Branch Panel: L1AA

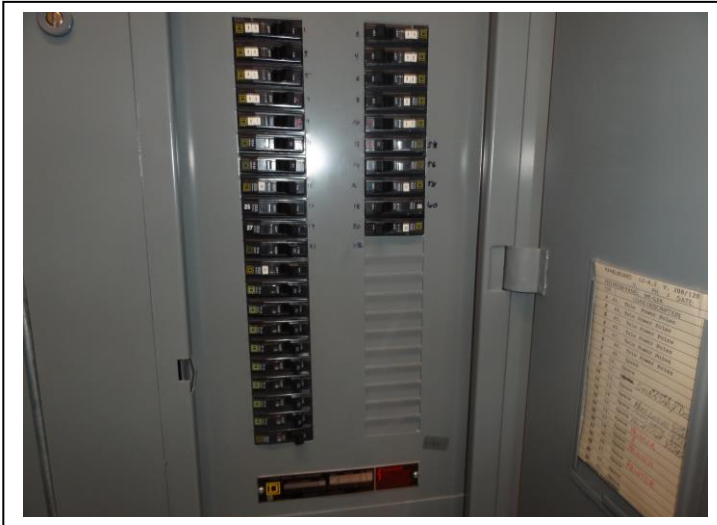
12. Please confirm Panel "L2A" will take the SQD QOB3100VH sub-feed breaker.

- **Based on the initial survey there is space in the existing panel for the new circuit breaker. However, LEO A DALY cannot confirm the exact model number. Please confirm with the manufacturer.**
